SUBJECT: Forwards addl info to complete NRC review of NUREG-0737, Item III.D.3.4, "Control Room Habitability," in response to NRC 840320 request. W/one oversize drawing. Aperture card is available in PDR.

Subject: Oconee Nuclear Station  
Docket Nos. 50-269, -270, -287  
Response to Request for Additional Information  
NUREG-0737 Item III.D.3.4  
Control Room Habitability

Duke Power Company  
Response to NRC Request for Additional Information  
Control Room Habitability - Oconee Nuclear Station

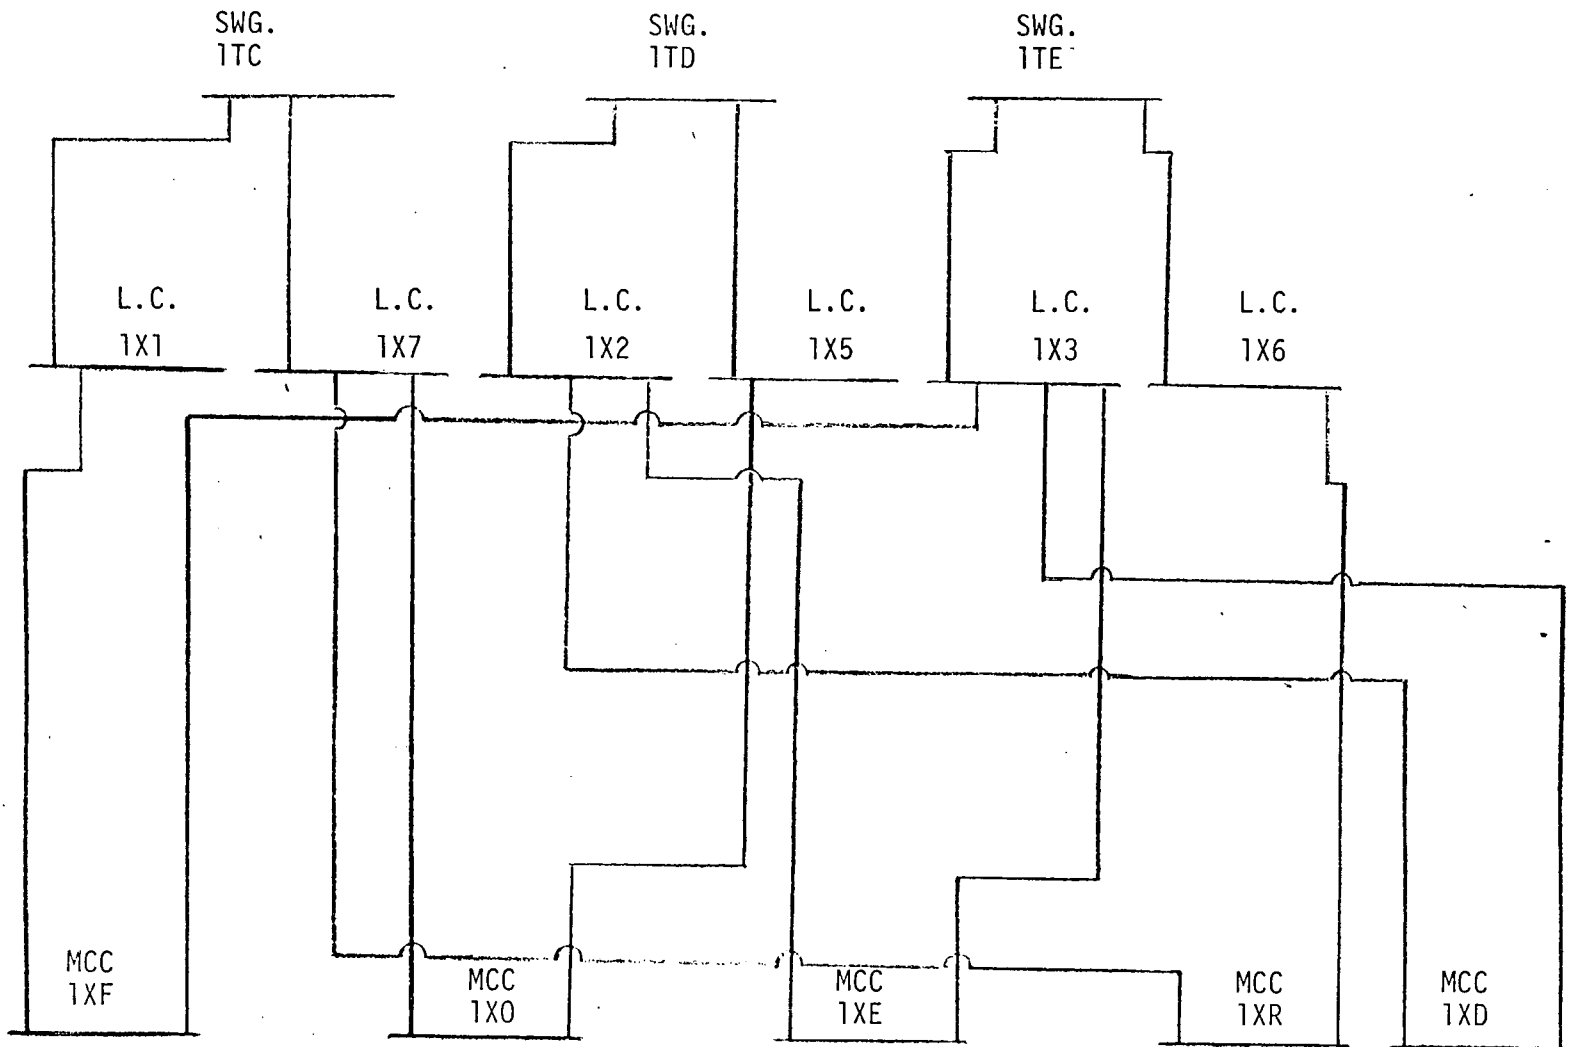
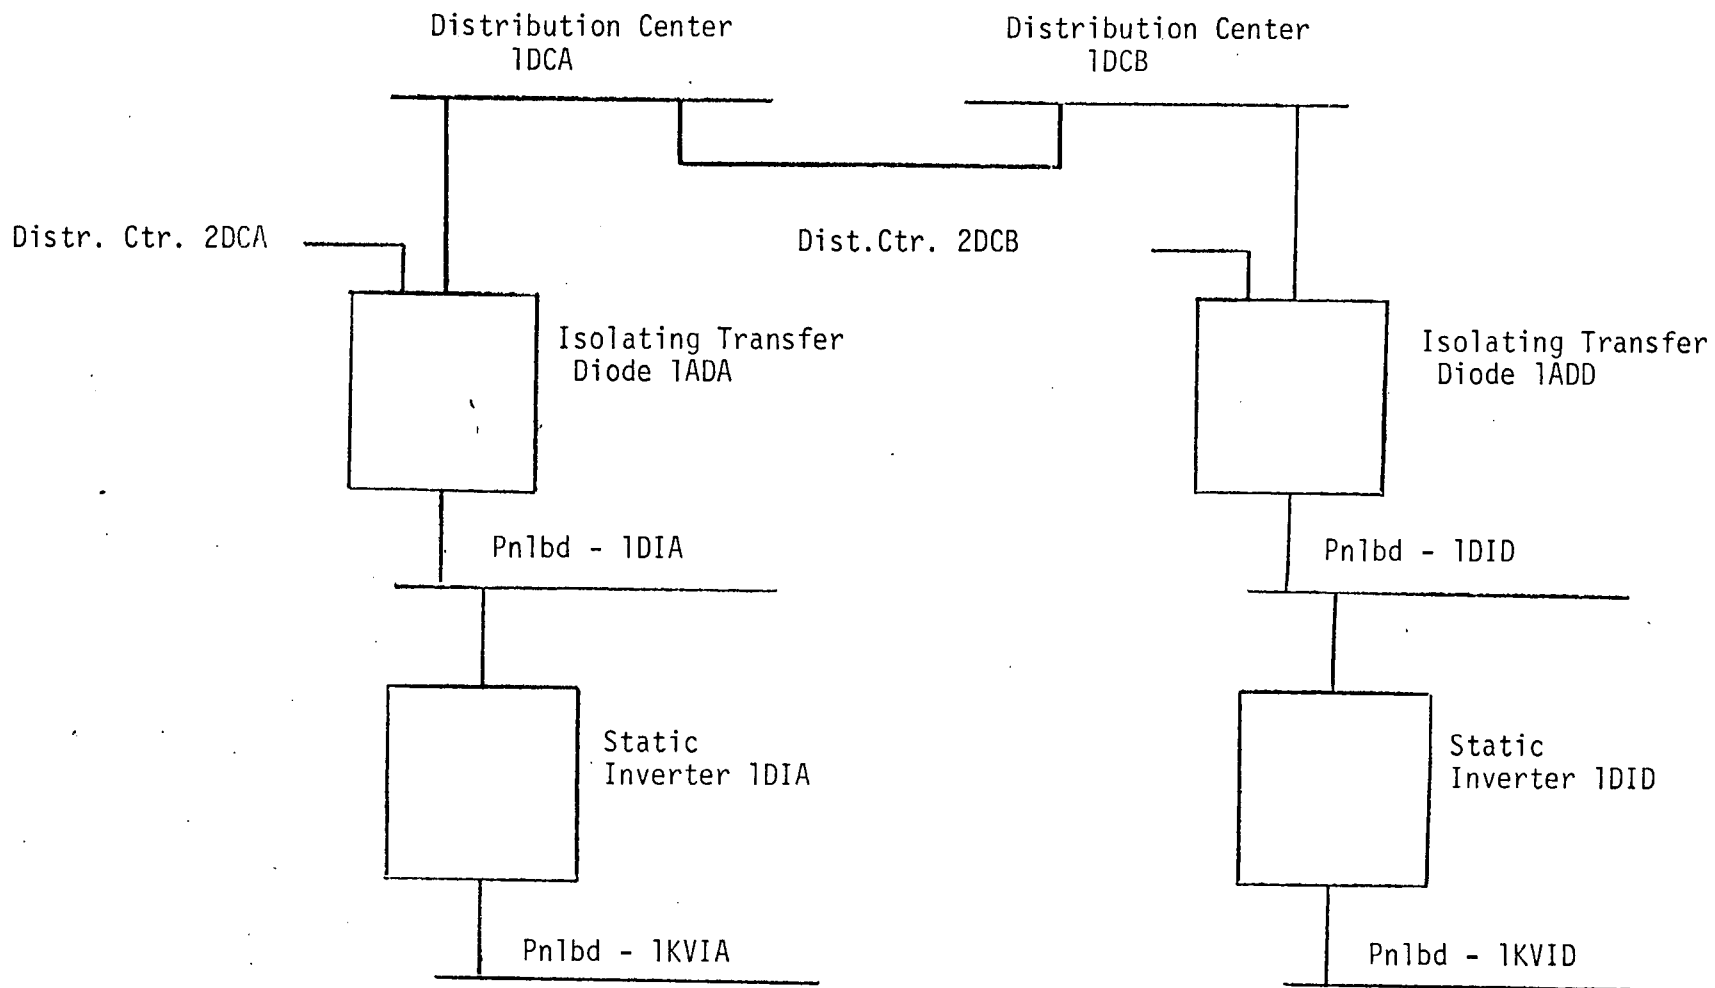
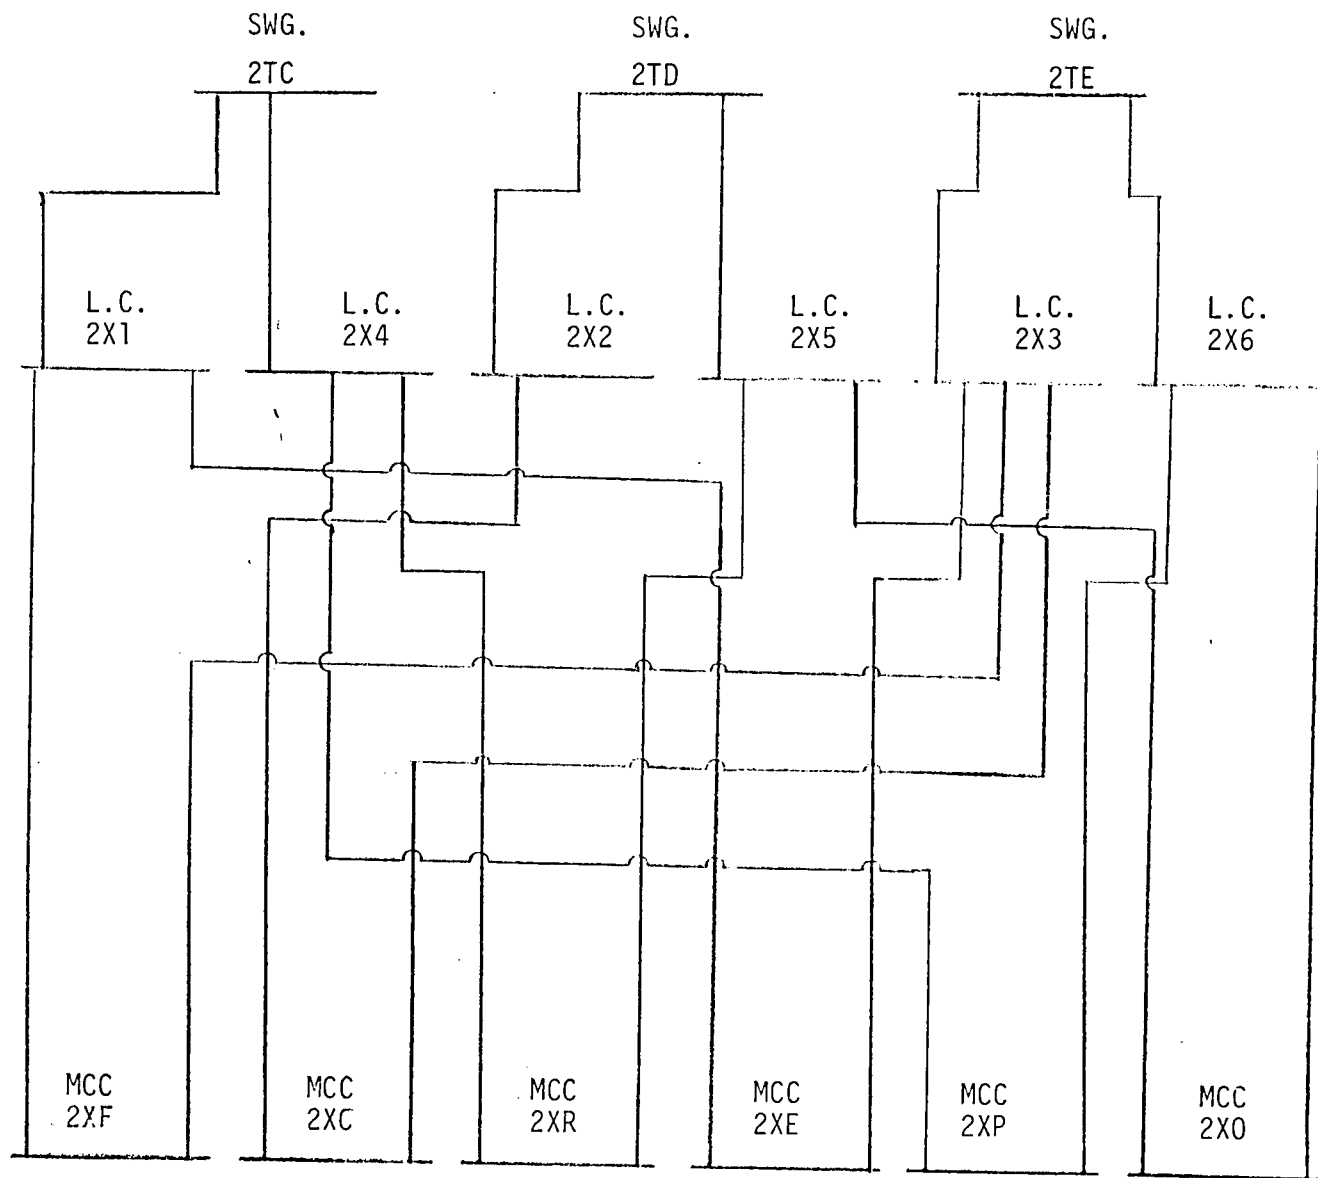
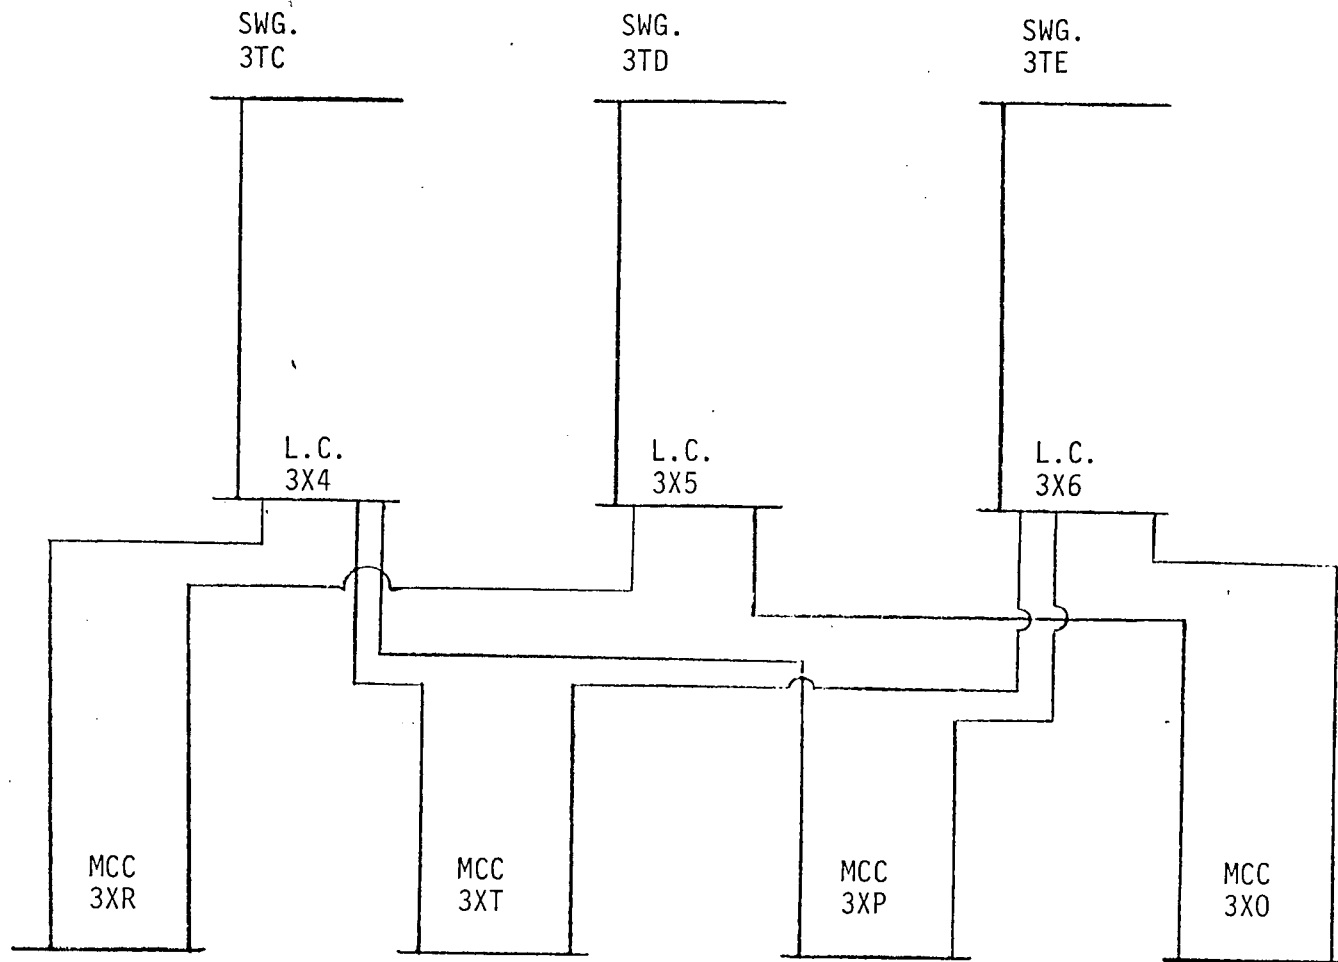
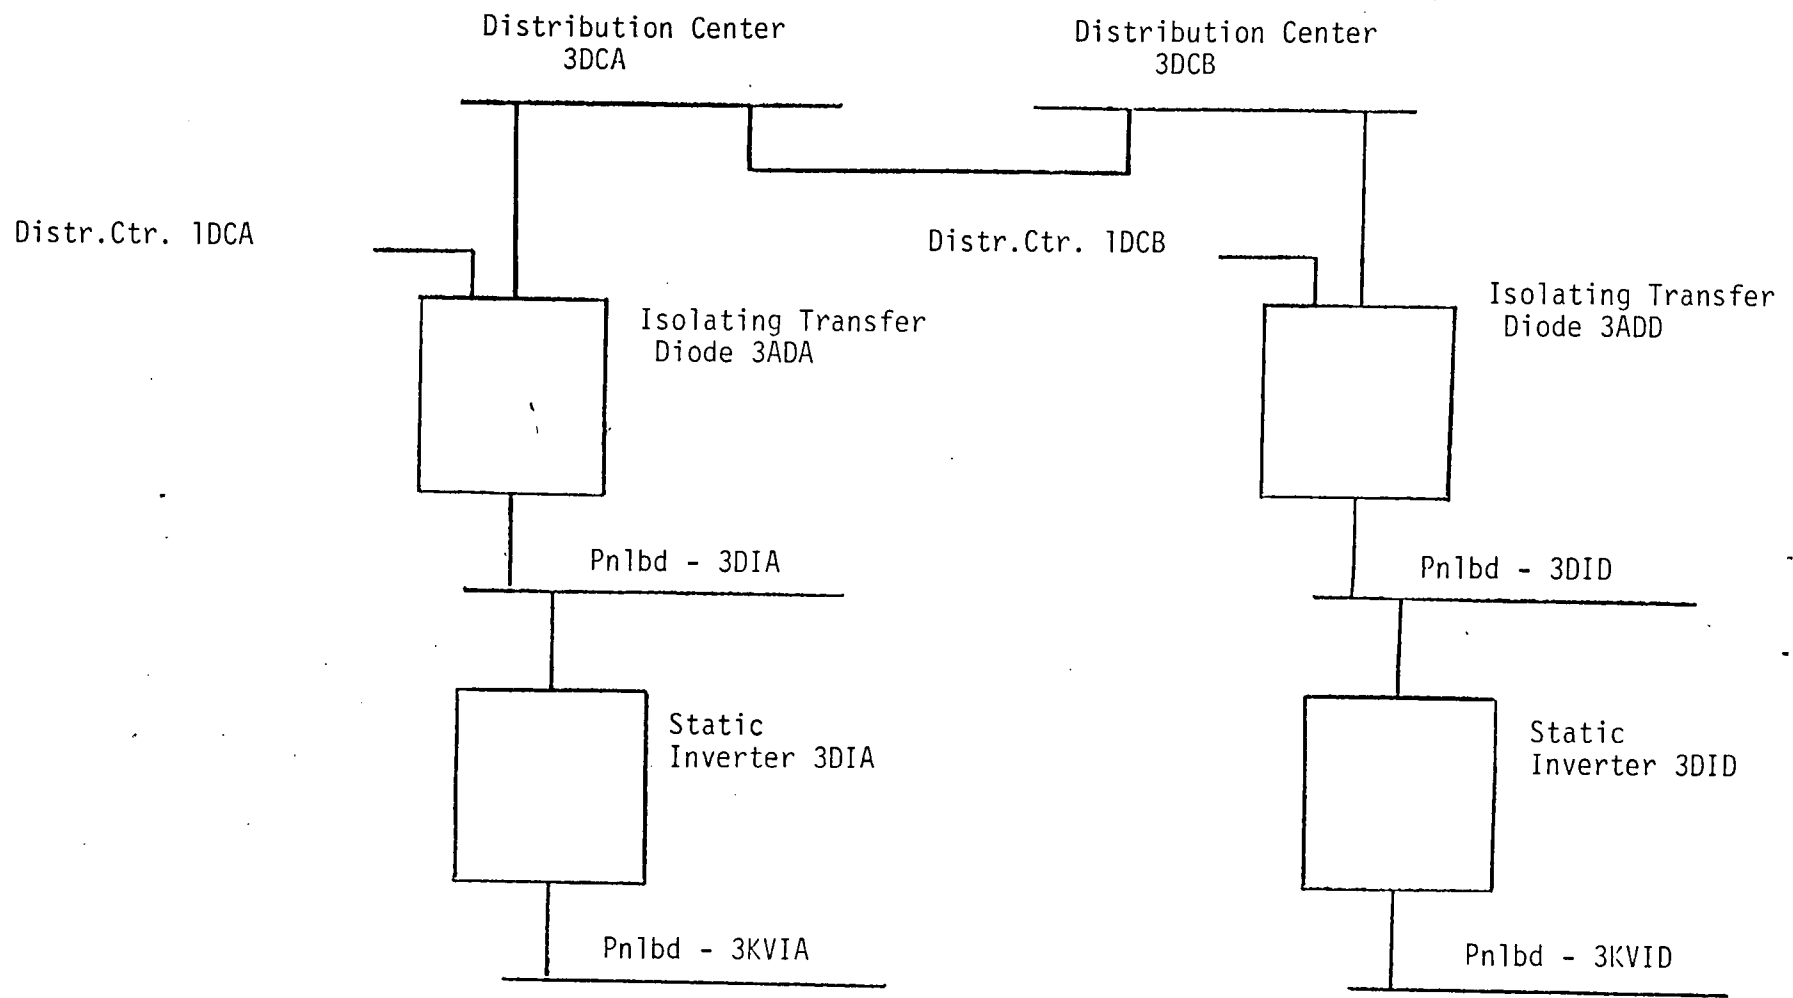
4. Provide information which shows that the control room emergency ventilation system is designed to function properly in the event of a loss-of-offsite power, or pipe breaks in areas adjacent to the control room.

With the distribution system that is installed, it is unlikely that any situation could occur that would cause a loss of all offsite power sources feeding Oconee. However, if this highly improbable situation did occur, then the 13.8KV underground feeder from Keowee Hydro would supply emergency power to the 4160V standby bus at Oconee as referenced in 8.3.1.1.3. In this situation, the majority of the non-essential loads would be load shed. As shown in Table 1, most of the Control Room HVAC loads are load shed. However, the control operators can, at their discretion, manually connect or disconnect loads on the Keowee underground circuit as necessary per Emergency Procedure EPOA1800/16 (Loss-of-Offsite Power). This procedure gives the operators the capability of operating beyond the design basis for Oconee since none of the Control Room HVAC loads are safety related.

Also attached are five figures which show the distribution system below the switchgear level that is required to feed the respective Control Room HVAC loads. Use these figures with attached Table 1 for correlation of HVAC equipment bus assignment and respective power source distribution.

FIGURE 6

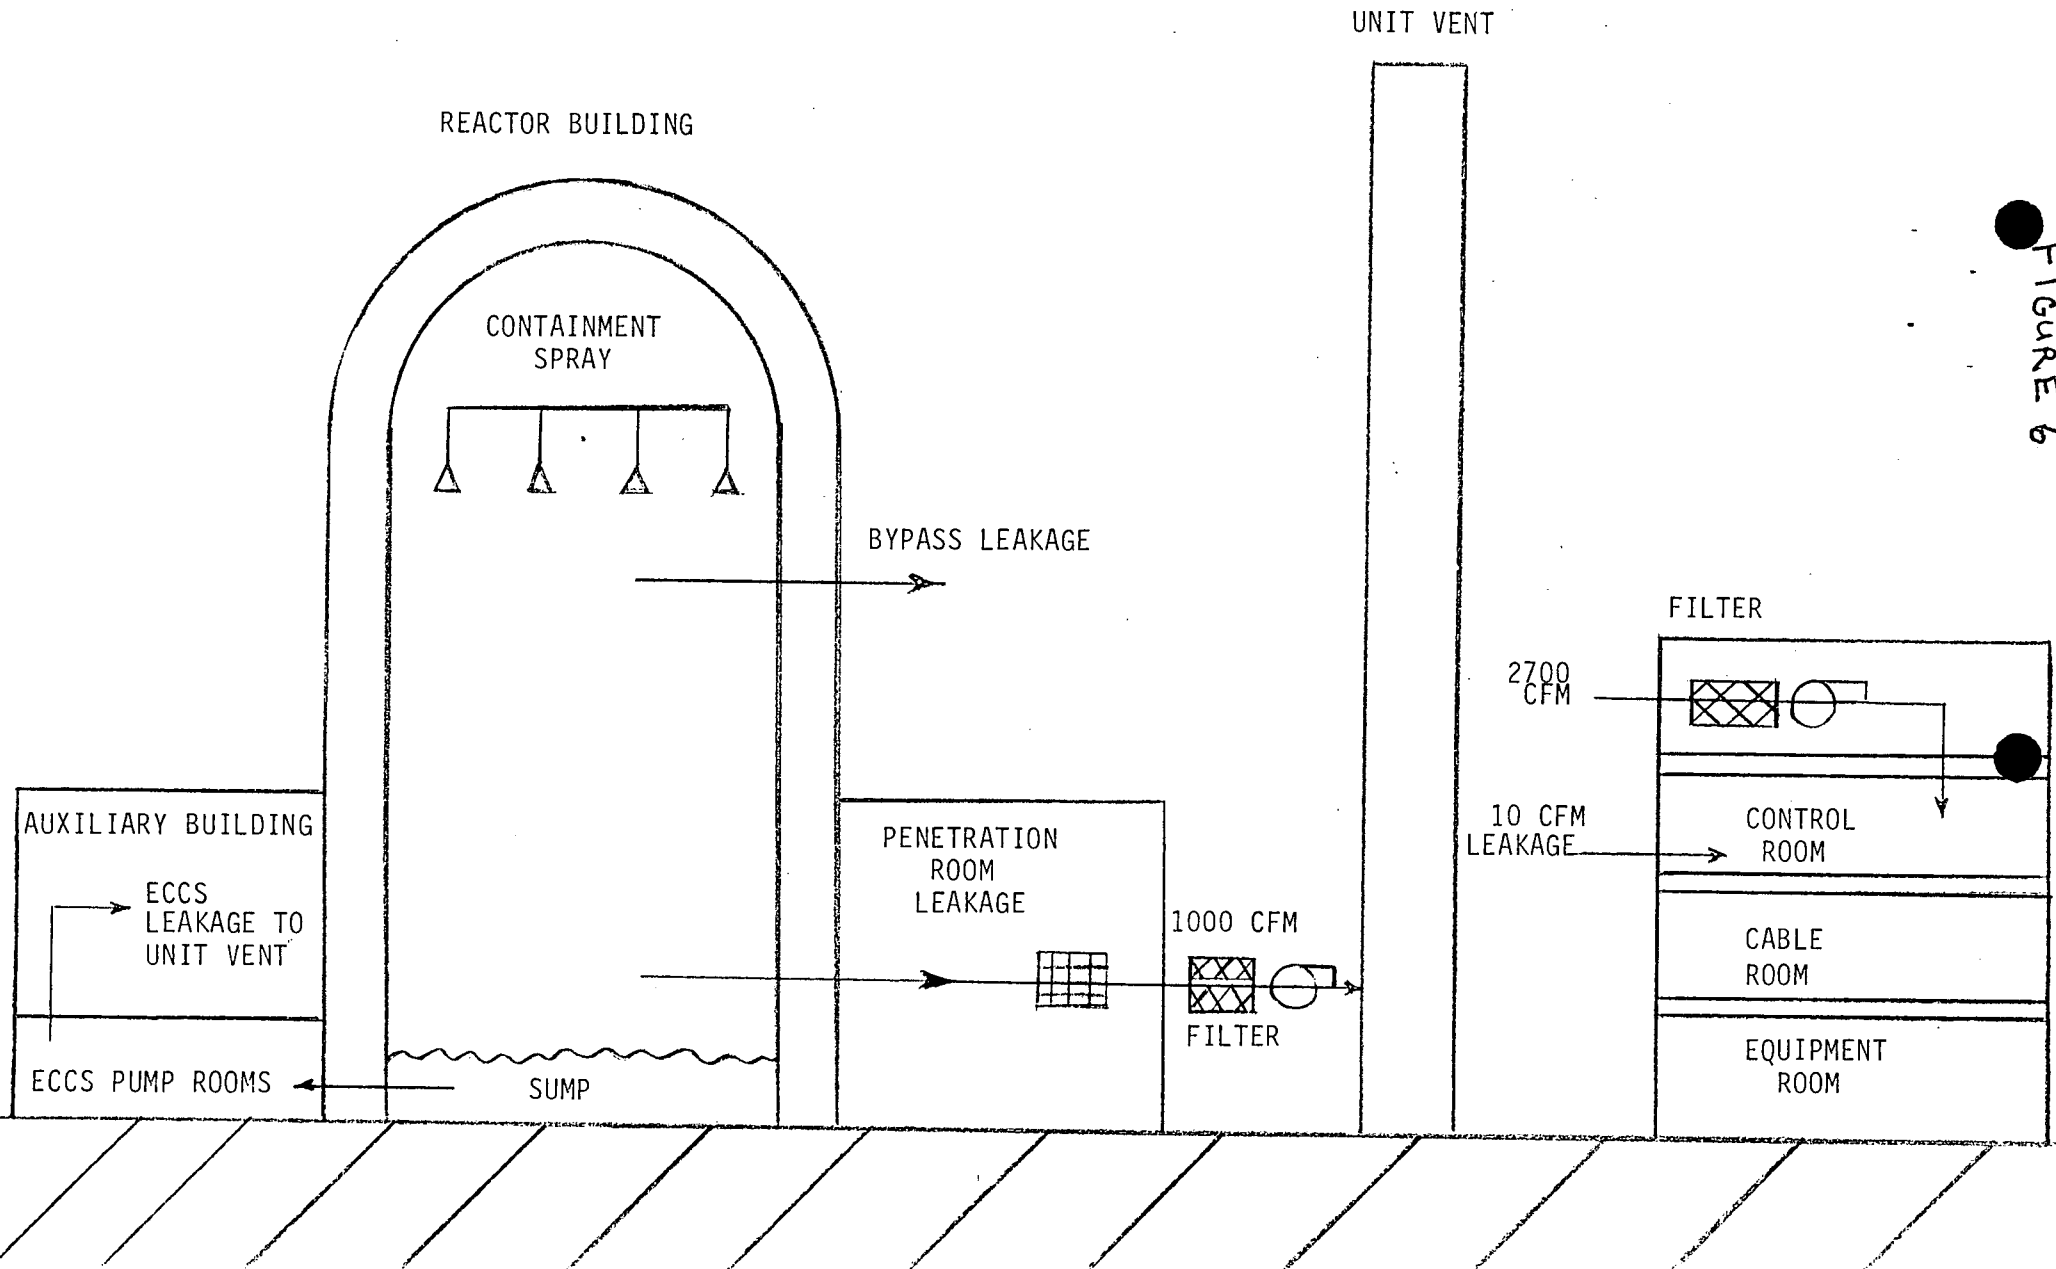
5. Provide analysis of control room operator doses following postulated design basis accidents. It may be necessary to look at DBAs other than a LOCA if the radiation release point is closer than that for LOCA to the control room air intake. The analysis should include a detailed listing of data and assumptions used, as well as the results.

coolant-accident which did not result in core damage beyond a pre-existing 1% fuel defect activity level. The initial post accident containment airborne activity consists of 100 percent core noble gases and 25 percent core iodines similar to Regulatory Guide 1.4. Containment source term depletion includes radiological decay, containment leakage, and elemental and particulate iodine removal by the containment sprays. Sump source term depletion consists of radiological decay only. Sources of activity released to the environment are containment bypass leakage, Penetration Room Ventilation System discharges, and ECCS leakage. See Figure 6 for model schematic. Assumptions and data are divided into the areas in which they are used.
